# Access Compliance Report

## Public Rights-of-Way

### (Curb Ramps)

Intersection ID: N/A	Main Street: INDEPENDENCE_DR	Cross Street: CONFERENCE_DR	Location: N
ADA ID: EFB7B2A3FA4F	Ramp Type: Perp	Initial Pass/Fail: Fail	Overall Compliance: No
			Severity Score: 13.75

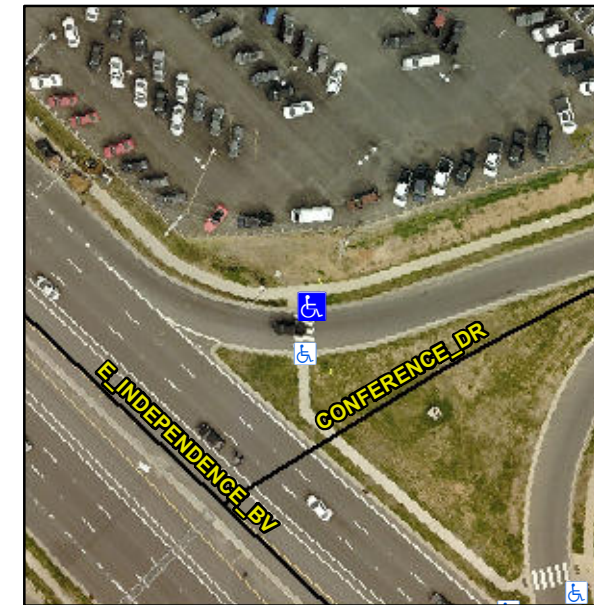
**Not Found, R304.2.2, R304.5.3**

Compliance	Description	Data	Compliance	Description	Data
N/A	Ramp Length (in)	71.5	No	Ramp Slope (%)	8.9
Yes	Ramp Width (in)	59.0	No	Ramp XSlope (%)	4.8
N/A	Flare Type LT	N/A	N/A	Flare Type RT	N/A
N/A	Flare Slope LT (%)	N/A	N/A	Flare Slope RT (%)	N/A
N/A	Flare Traversable LT?	N/A	N/A	Flare Traversable RT?	N/A
N/A	Landing Length (in)	N/A	N/A	DWS Provided?	N/A
N/A	Landing Width (in)	N/A	N/A	DWS Contrast?	N/A
N/A	Landing Slope (%)	N/A	N/A	DWS Length (in)	N/A
N/A	Landing X Slope (%)	N/A	N/A	DWS Full Width?	N/A
N/A	Landing Curb? (Y/N)	N/A	N/A	DWS Offset (in)	N/A
N/A	Shared Landing?	N/A			
N/A	Gutter Ponding?	N/A	N/A	Gutter Slope (%)	N/A
N/A	Gutter Lip Ht (in)	N/A	N/A	Gutter X Slope (%)	N/A
N/A	Painted X Walk1?	Yes	N/A	Painted X Walk2?	N/A
	X Walk 1 Direction	To S		X Walk 2 Direction	N/A
N/A	X Walk 1 Width (in)	119.0	N/A	X Walk 2 Width (in)	N/A
	X Walk 1 Slope (%)	6.6		X Walk 2 Slope (%)	N/A
	X Walk 1 X Slope (%)	4.1		X Walk 2 X Slope (%)	N/A

**Remove & Replace Entire Ramp.**
